ADDENDUM NO. 2

TO: PLANS AND SPECIFICATIONS FOR STATE OF MISSOURI

Replace Water Distribution System
Algoa Correctional Center
Jefferson City, Missouri
PROJECT NO.: C2403-01

**SHEET C-006 REVISIONS (ADDENDUM NO. 2)
 SOFTENER BUILDING PROPOSED CONDITIONS**

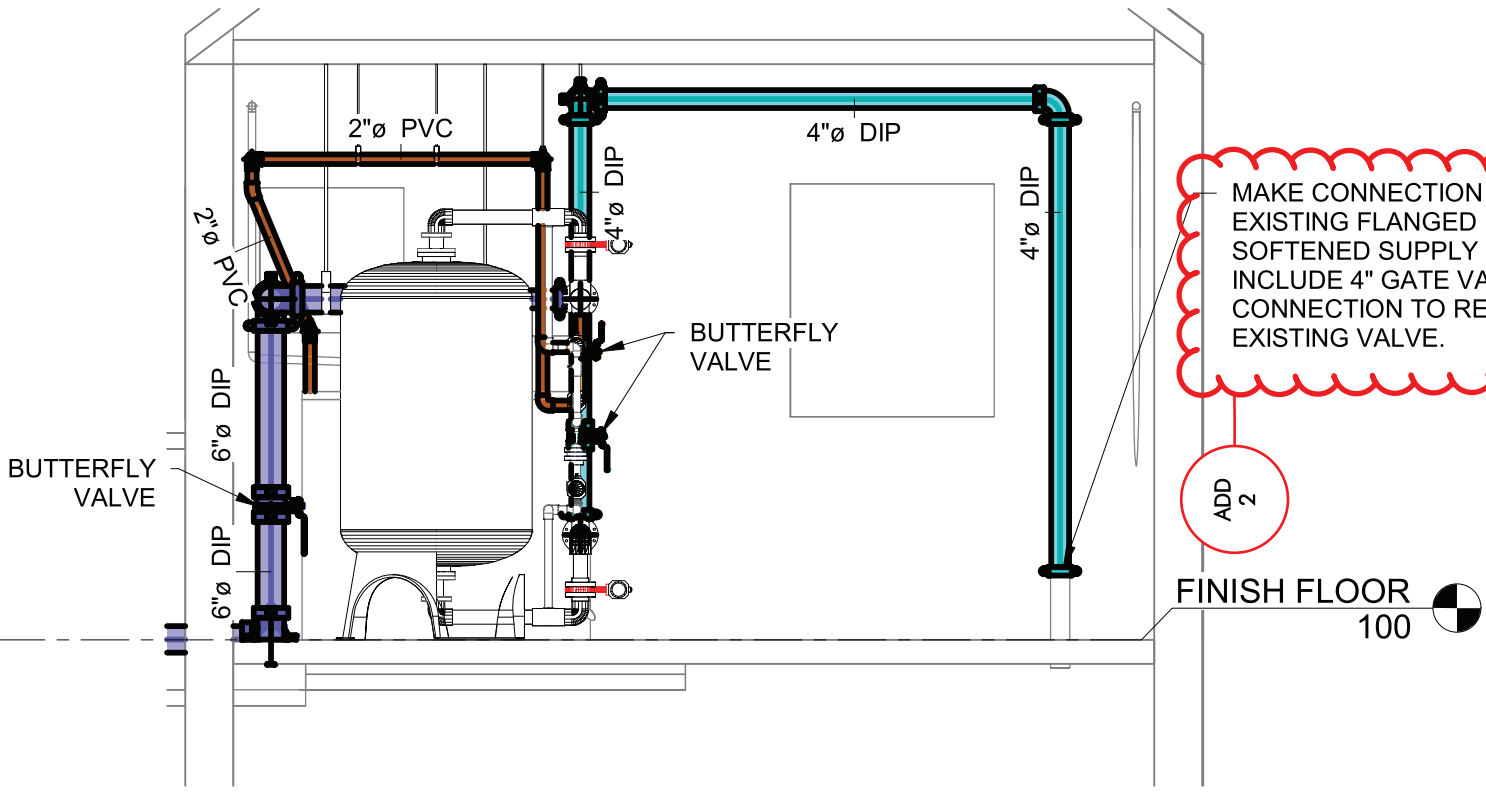
1. SHEET C-004 – SOFTENER BUILDING DEMOLITION PLAN, Detail 4-Demo Elevation View
 - a. REVISE Brine Tank Note: Existing brine tank(s) is/are to be replaced with tank(s) of identical volume.
2. SHEET C-006 – SOFTENER BUILDING PROPOSED CONDITIONS
 - a. REVISE DETAIL 1, PROPOSED BUILDING PIPING AND EQUIPMENT, NOTE 1:
 1. Coordinate installation and startup of the proposed water softening system with Owner's water treatment service contractor:

- COORDINATE INSTALLATION, AND STARTUP OF THE PROPOSED WATER SOFTENING SYSTEM WITH THE OWNER'S WATER TREATMENT SERVICE CONTRACTOR:
 WALTER LOUIS FLUID TECHNOLOGIES
 530 S. 5TH STREET
 QUINCY, IL 62301
 217.223.2017
 SALES@WALTERLOUIS.COM
- ALL PIPING IN BUILDING IS TO BE RESTRAINED JOINT PIPE. REPLACE ALL AIR LINES FROM AIR COMPRESSOR TO CONTROL VALVES.
- CONTRACTOR TO FIELD VERIFY ALL DIMENSIONS.

NW PROPOSED ELEVATION

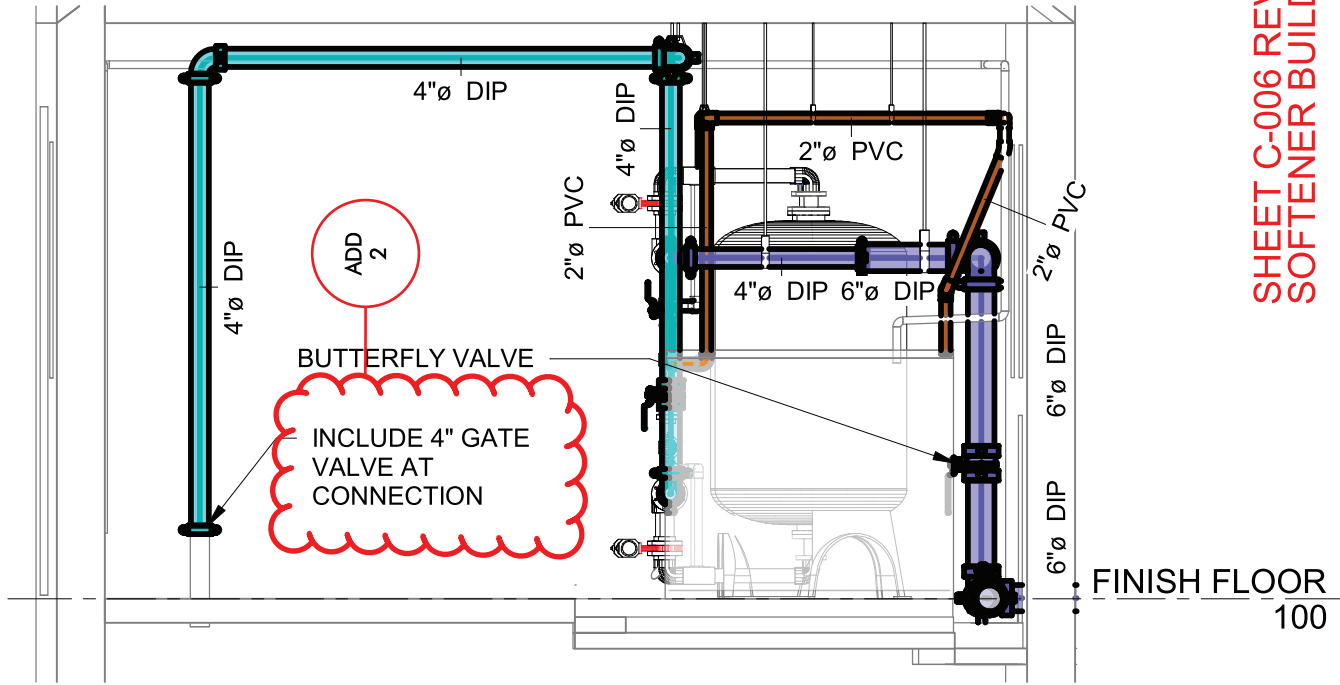
MAKE CONNECTION TO EXISTING FLANGED FACILITY SOFTENED SUPPLY LINE INCLUDE 4" GATE VALVE AT CONNECTION TO REPLACE EXISTING VALVE.
